ITR SET NOTE:
 THESE ITR SET DRAWINGS HAVE BEEN MARKED UP WITH KNOWN MARKUPS/REVISIONS IN PROCESS AS NOT TO BE RE-COMMENTED ON VIA THE ITR PROCESS & ADVISE ITR REVIEWER OF KNOWN FORTCOMING CHANGES. THESE MARKUPS HAVE BEEN DONE / IDENTIFIED WITH YELLOW BACKGROUND TEXT BOXES. PLEASE USE ALTERNATE COLOR FOR ITR COMMENTS WHICH I WILL REVIEW / TAKE INTO CONSIDERATION BEFORE CADD/DESIGN IS TO EXECUTE.

| DEPARTMENT OF THE NAVY NAVAL FACILITIES ENGINEERING COMMAND ~ MID-ATLANTIC JACKSONVILLE, NC MCB CAMP LEJEUNE JACKSONVILLE, NC P1338 II MEF SIMULATION/TRAINING CENTER REPLACEMENT MECHANICAL - SITE PLAN | | |

PRE-FINAL ITR SET 2021-05-28

ATFP EQUIPMENT BRACING DETAIL
SCALE: NTS

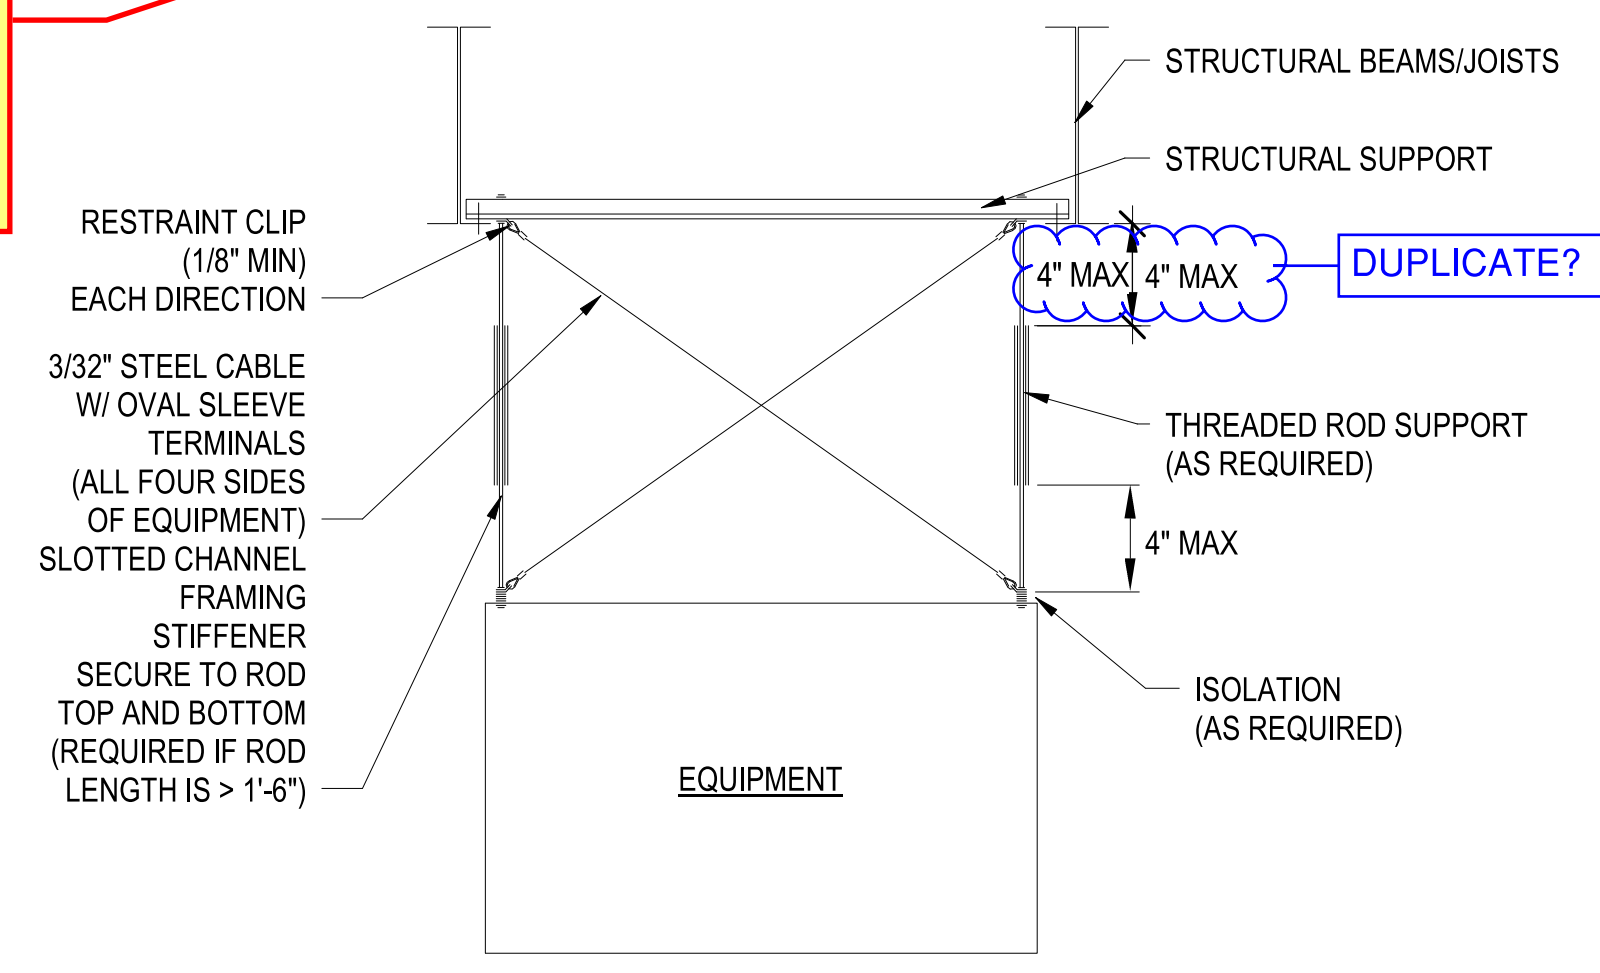
KEEP FOR NOW; CONFIRM WITH JASON MILLER

2 SPLIT DX HEAT PUMP - CONTROL DIAGRAM SCALE: NTS

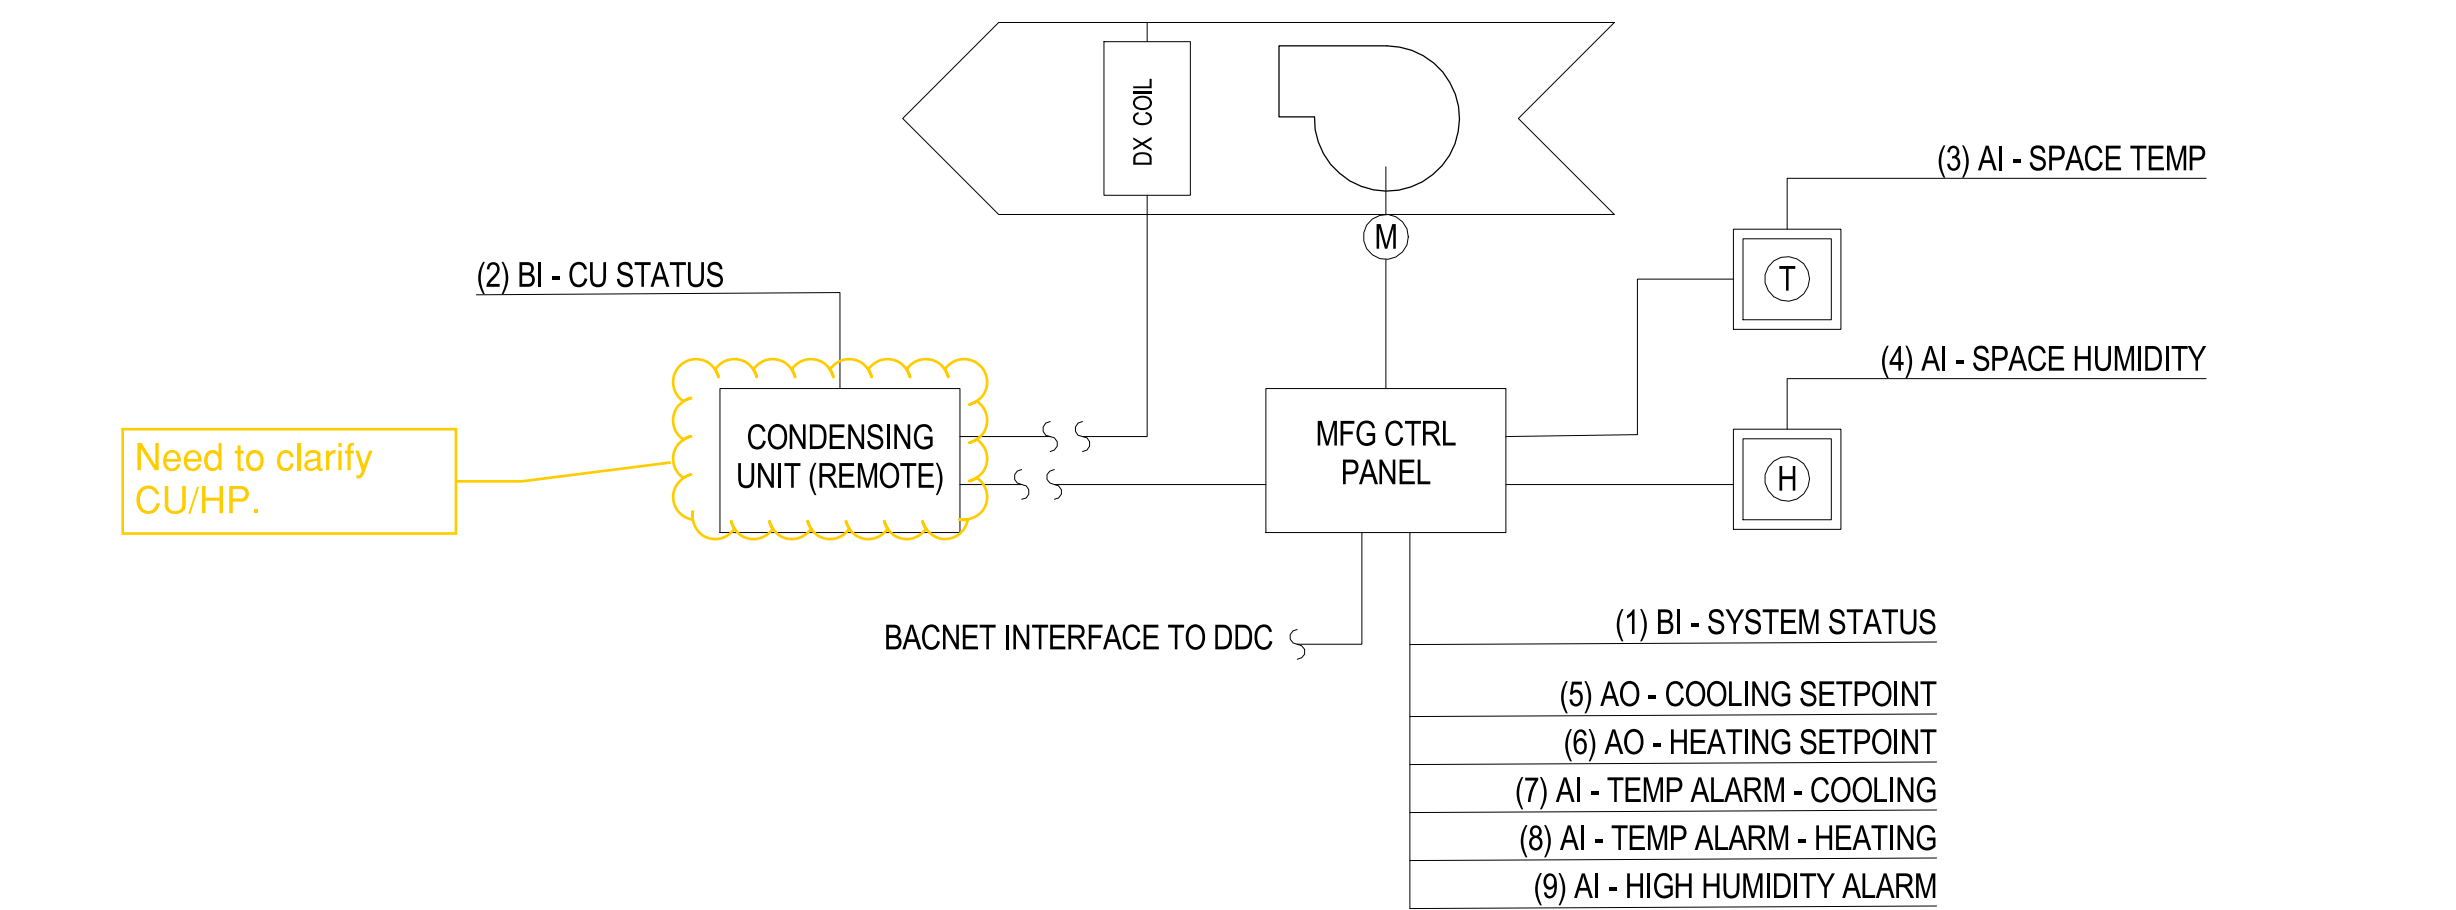
ELEC SHOULDN'T HAVE HYDRONIC HEAT
